Submission opposing the Narrabri Lateral Gas Pipeline

Wando Conservation & Cultural Centre Inc, Maules Creek, Narrabri wandoccc@gmail.com
December 2025

This submission addresses the inadequacy of the Narrabri Lateral Pipeline (NLP) Environmental Impact Statement (EIS) in relation to the following main subjects of concern:

Screenshot of Fig 4.21 Groundwater Dependent Ecosystems, p. 54 Technical Report 2.

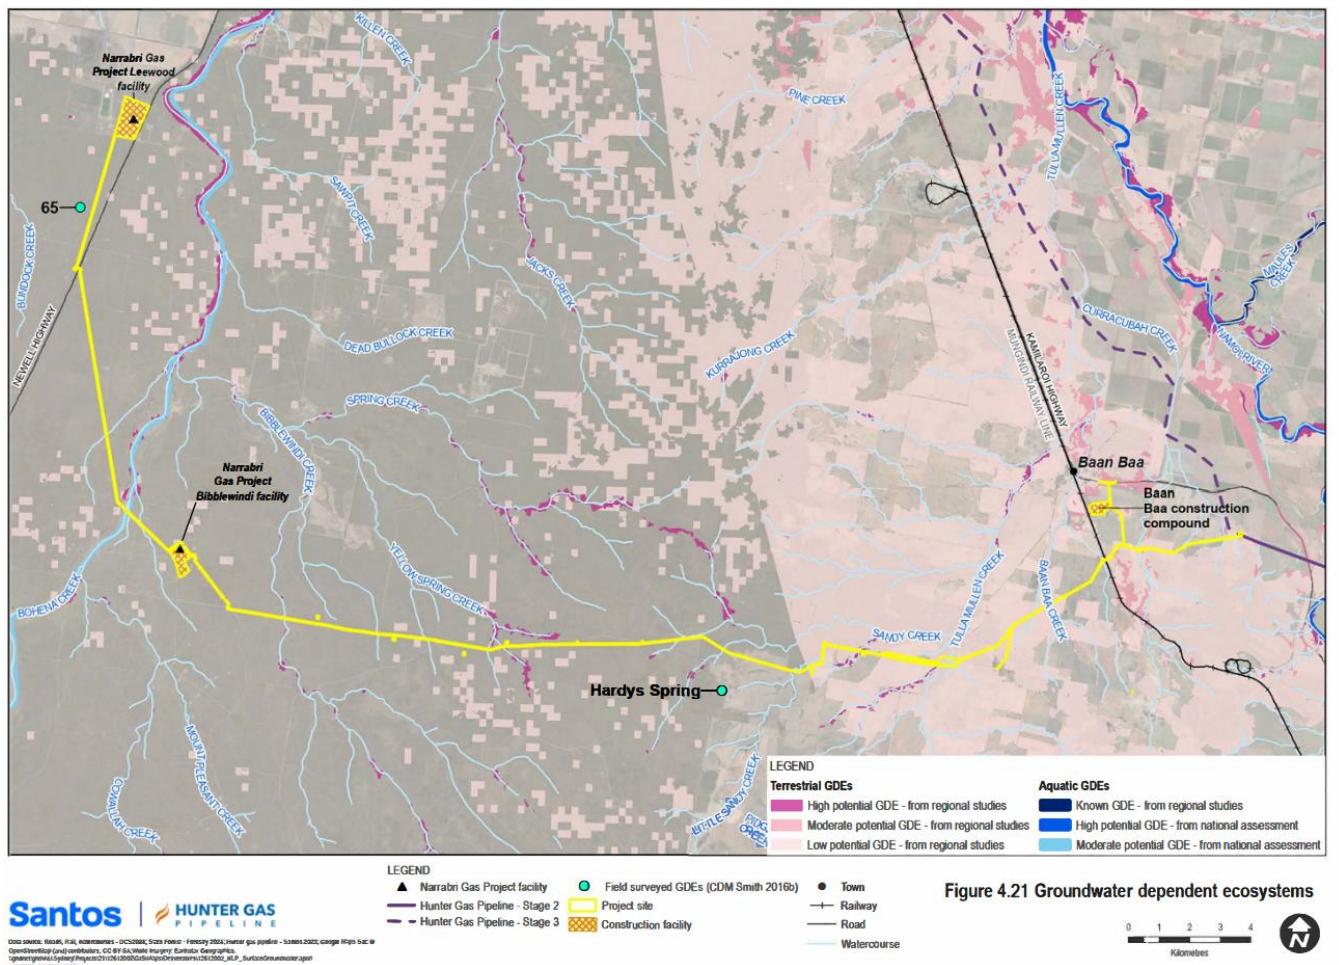
potential" aquatic GDE. Other intersecting streams are simply left "unclassified". Strangely, the Figure 2.2 Aquatic habitat survey locations in Technical Report 2 Aquatic Habitat does not even show Yellow Springs Dam, a permanent partly spring-fed and partly surface water-fed reservoir shortly downstream of the proposed gas pipeline. This curious decision to omit a significant water resource smacks of either scientific negligence or alternatively, scientific misconduct, and has severe negative consequences for both baseline assessment and impact assessment.

The approach in Technical Report 2 approach repeats the over-simplification criticised by Serov for the Narrabri Gas Project EIS. Despite the strong evidence of stygofauna in the NGP area, the Narrabri Lateral Pipeline EIS does not include any stygofauna surveys. The term “stygofauna” does not appear in the Aquatic Ecology report, the BDAR or Chapter 6.
